UNITED STATES PATENT AND TRADEMARK OFFICE

APPLICATION NO.	FILING DATE	FIRST NAMED INVENTOR	ATTORNEY DOCKET NO.	CONFIRMATION NO.
10/573,560	03/27/2006	Wolfgang Haller	23496	7149
535 7590 01/08/2007 THE FIRM OF KARL F ROSS 5676 RIVERDALE AVENUE PO BOX 900 RIVERDALE (BRONX), NY 10471-0900			EXAMINER NGUYEN, PHUONGCHI T	
			ART UNIT	PAPER NUMBER
			2833	
SHORTENED STATUTORY PERIOD OF RESPONSE		MAIL DATE	DELIVERY MODE	
3 MONTHS		01/08/2007	PAPER

Office Action Summary	Application No.	Applicant(s)	
	10/573,560	HALLER, WOLFGANG	
	Examiner	Art Unit	
	Phuongchi Nguyen	2833

DETAILED ACTION

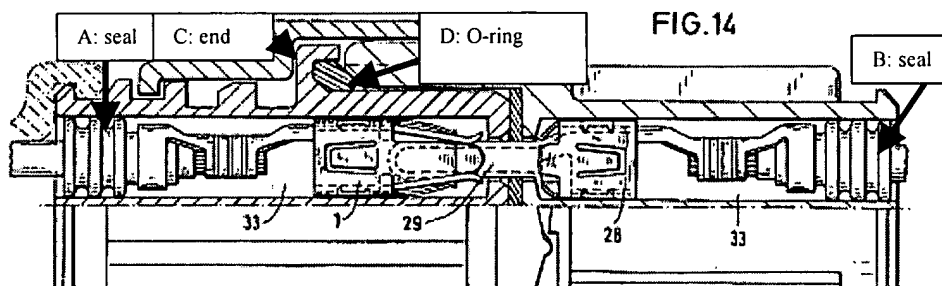
whereby on the plug housing (34) and on the coupling housing (35), each respective seal (A, B) is provided against the outer jacket of the cable (see marked-up 1).

In regards to claim 5, Zinn discloses the plug connector characterized in that the plug housing (34) and the coupling housing (35) have a cylindrical enlargement in the region turned toward the cable and in which the seal (A, B) is set and fixed (see marked-up 1).

In regards to claim 9, in view of claim 5, the seal of Zinn must have one longitudinally extending spreading gap or opening for the cable going through (marked-up 1).

In regards to claim 12, Zinn discloses the plug connector characterized in that within the plug (34) or the coupling housing (35) are provided and that at the ends (C) turned away from the cable have sealing rings (D) that correspond to the seals (A, B) between the plug housing (34) and the coupling housing (35) and the cable (see marked-up 1).

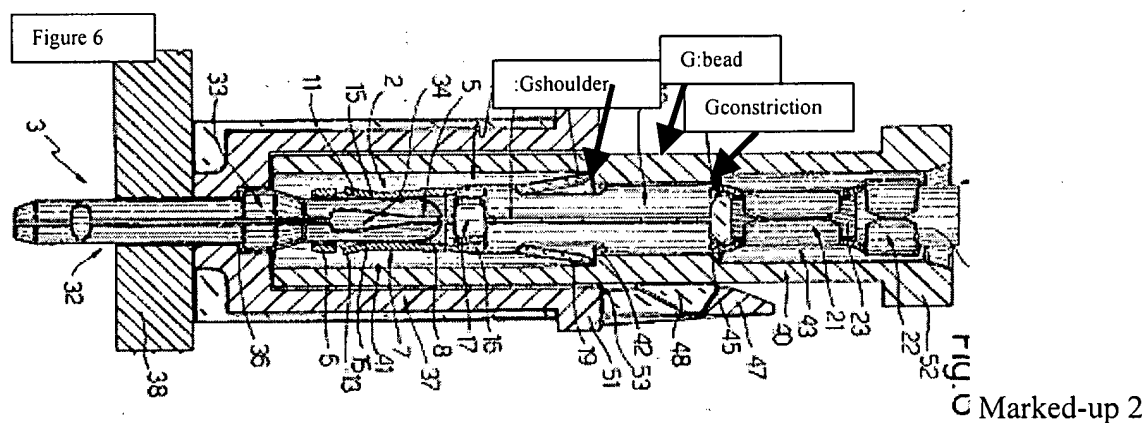
Zinn discloses the invention generally all as claimed, but lacks a locking part and detent hook. However, Galizia et al teaches the plug (of 37) and the coupling (of 40) each have a locking part (47, 48) of a locking unit for fixing the plug (of 37) and the coupling (of 40) relative to one another, and

whereby the contact pin (3) and the contact sleeve (1), the contact sleeve (1) have at least one detent hook (19) (figs. 2 and 6) that, upon insertion of the contact pin (3) and the contact sleeve (1) in the respective plug housing (37) and the coupling housing (40), the detent hook (19) engages behind a respective shoulders (G_{shoulder}) therein (see marked-up 2) and; the shoulder is a component of the bead (G bead).

Marked-up 3 (figure 10 of Puerner)

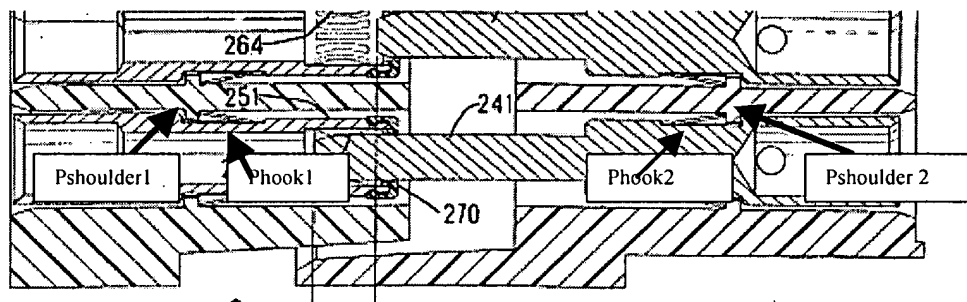
In regards to claim 2, Zinn discloses the invention generally all as claimed, but lacks a detent hook on the contact pin corresponding with the shoulder on the plug housing. However, Puerner teaches the plug connector characterized in that the contact pin (141) and the contact sleeve (151) each are formed with two, preferably diametrically oppositely arranged, detent hooks (Phook1, Phook2) and the shoulder (Pshoulder1, Pshoulder 2) is configured as an annular shoulder (PD) (see marked-up 2). It would have been obvious to one having ordinary skill at the time the invention was made to modify the plug connector assembly of Zinn et al by providing another detent hook as taught by Puerner on the contact pin for locking of the contact pin on the plug housing.
